REPLACEMENT SYSTEM VARIANCE REQUEST

SUBSURFACE WASTEWATER DISPOSAL SYSTEM APPLICATION

SUBSURFACE WASTEWATER DISPOSAL PLAN

On this date a site visit was made to and on the property of Mr. and Mrs. James Carey Jr.. The property is located in the town of Augusta at the junction of Hwy 105 and Ward Road. Present with me were yourself, Gary Fuller of your office, Ken Meyer of Health Engineering, Mrs. Carey, and near the end Marshall Swann-a local contractor.

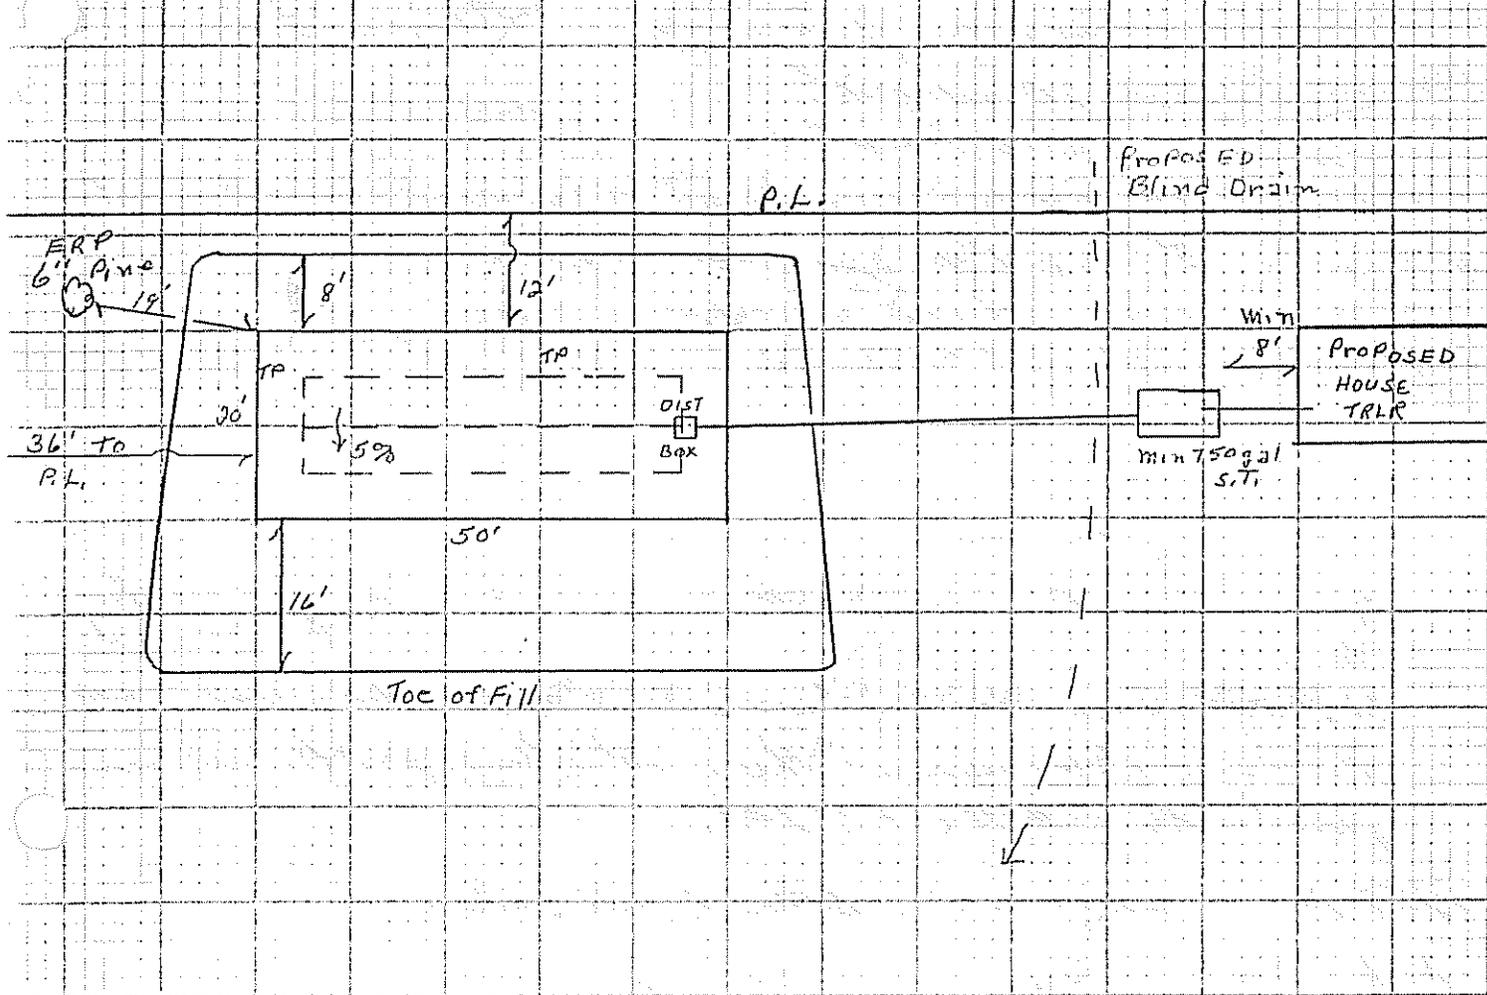
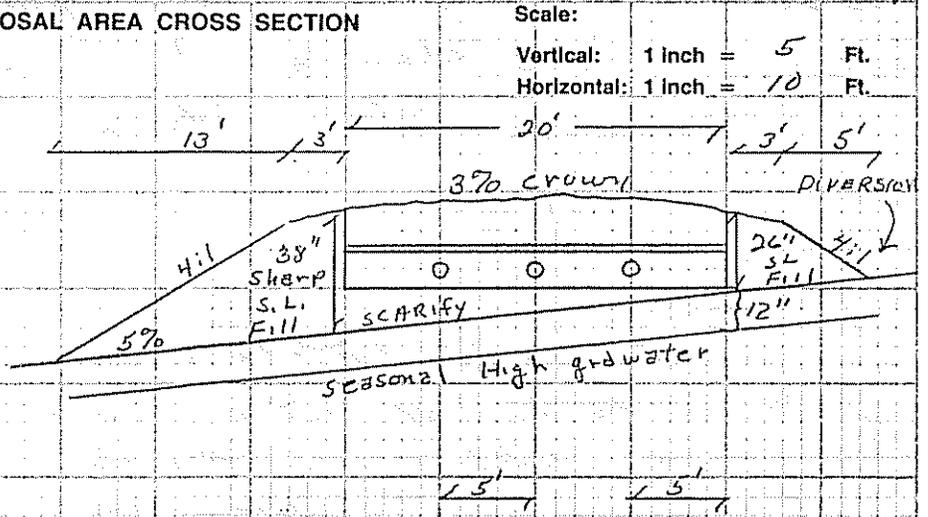
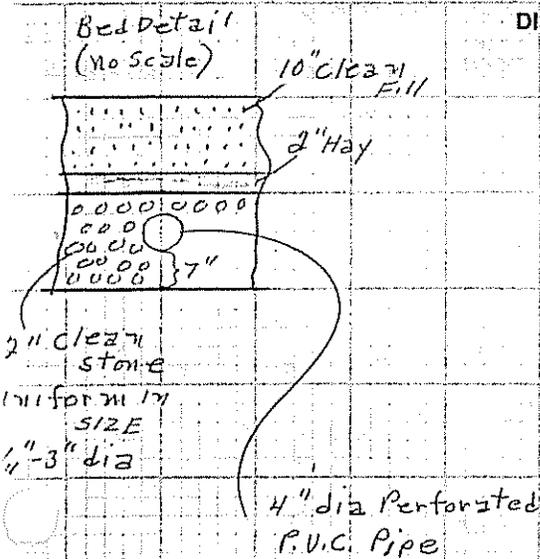
We noted an excavated hole at the
outlet end of the soft tank and ~~could~~^{see} a semi-crushed or flattened
4" drain pipe. This to exclude Roger Webster determined
that the top fill was not what he specified in the design
work, that there was too much clay deposits in the fill and
in question what may be under the stone based on cuttings and top.

Our observations of these holes at the site (subsurface wastewater disposal system) indicate that: 1) the pipe from the septic tank to the field is flattened and may have a bend in it and 2) there appears to be an excess of heavy soil i.e. silt loam to silty clay loam, in the field above the stone and alongside of the bed. A check of the drainage pipe elevation shows this to be okay. We were without the benefit of a backhoe, consequently no other test sites were dug.

RECOMMENDATIONS: At a minimum, 1) the connecting pipe from the septic tank to the field should be replaced, 2) the fill over and around the bed should be removed and replaced with a clean sharp sandy loam to loamy sand material.

- 1) Remove & replace crushed drain pipe on the outlet side of the soft tank.
- 2) Excavate and remove top fill and provide fill as per enclosed design plan.
- 3) ~~Excavate~~ Excavate two trenches next to the drain lines in the field and determine whether or not the proper fill has been placed under the drain bed.

On June 15, 1892 Mr. Whitlock excavated the top fill and had
excavations of it from the system and spread it out beyond the field.
The fill he used to replace the old fill was a sharp sand,
and he capped over the system with a beam. I had met with
Roger Webster at which he had stated that the fill excavations of
the original system had to be removed do to the clay content.
